**Build a Better Bridge Faster  
White Paper  
Provided to Governors Christine O. Gregoire and John A. Kitzhaber, M.D.  
By the members of the  
CRC Urban Design Advisory Group  
March 11, 2011**

Since this letter was written, the Independent Review Panel and Bridge Expert Review Panel reports have been published and thoroughly reviewed and considered. Chapter 2 of the FEIS outlines what the CRC project has done with these recommendations and how they have affected the project. See below for responses to specific comments.

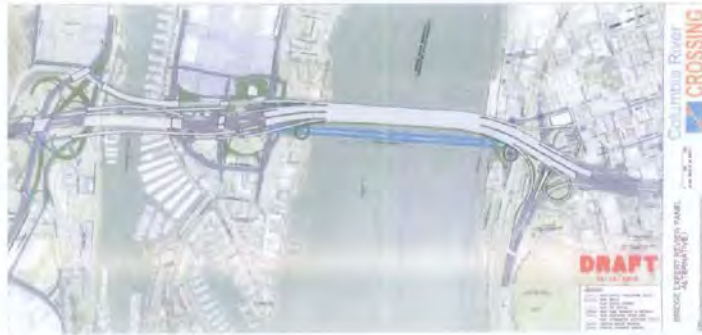
If the recommendation by the Bridge Review Panel to replace the Harbor Bridge (*Bridge Review Panel Final Report, p. 103*) was recognized, then there would need to be additional Island ramp reconfiguration. That would have likely impacted the Jantzen Super Center parking lot.

Without consideration of the Bridge Review Panel recommendation on the Harbor Bridge, Marine Drive and Hayden Island Interchanges, it is straightforward to hook up the cable-stayed bridge to the existing design of the ramps and absolutely keep the agreement with the Hayden Island Community and the Jantzen Beach Super Center.

It is unknown whether the BO would have needed revisions with the cable-stayed or deck truss bridges as these bridge types were not selected. NMFS confirmed that revisions were not necessary to cover the selected bridge type - the composite deck truss.

For cost savings purposes, the project has elected to keep the North Portland Harbor bridges rather than replace them.
